ORIGINATION FORM •

Proposed Revisions to a Standard Plans Index

Index Number: 102-607 Sheet Number (s): 1

Index Title: Mobile Operations

WORK ON SHOULDER = (Two-Lane Roadway Shown, Multilane Roadway Similar)

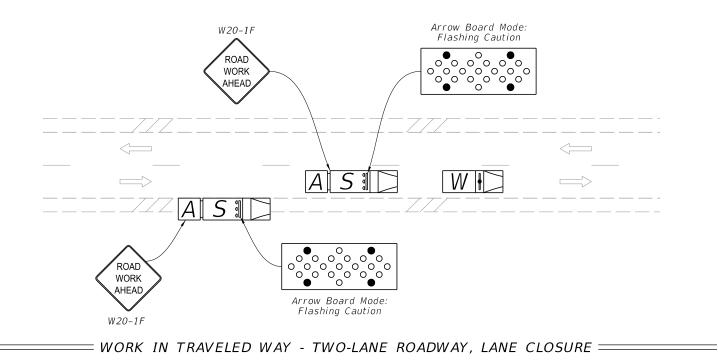
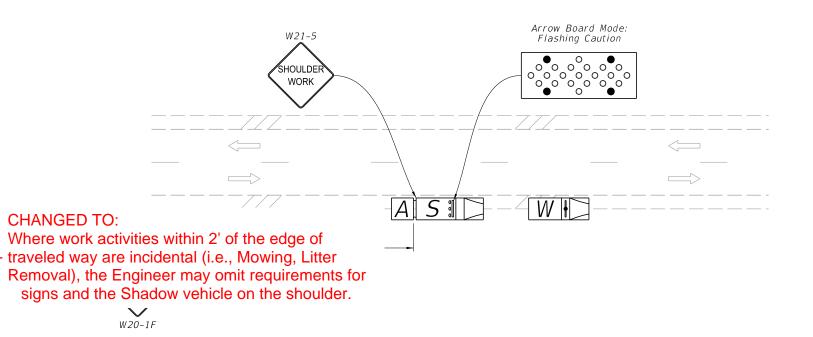
Sheet1: Changed General Note 4 to: Where work activities within 2' of the edge of traveled way are incidental (i.e., Mowing, Litter Removal), the Engineer may omit requirements for signs and the Shadow vehicle on the

shoulder.

Delete the last part of Note 4 due to redundancy with Spec 102 that requires vehicles in the work area to have operating high-intensity rotating, flashing, oscillating, or strobe lights. Changed "delete" to "omit" in Note 4 to be consistence with the language in 102-602 Note 3.

- 4. Where work activities within 2' of the edge of travel way are incidental (i.e., Mowing, Litter Removal), the Engineer may delete requirements for signs and the Shadow vehicle on the shoulder provided vehicles in the work area have high intensity rotating, flashing, oscillating, or strobe Lights operating.

- 4. Where work activities within 2' of the edge of travel way are incidental (i.e., Mowing, Litter Removal), the Engineer may omit requirements for signs and the Shadow vehicle on the shoulder.
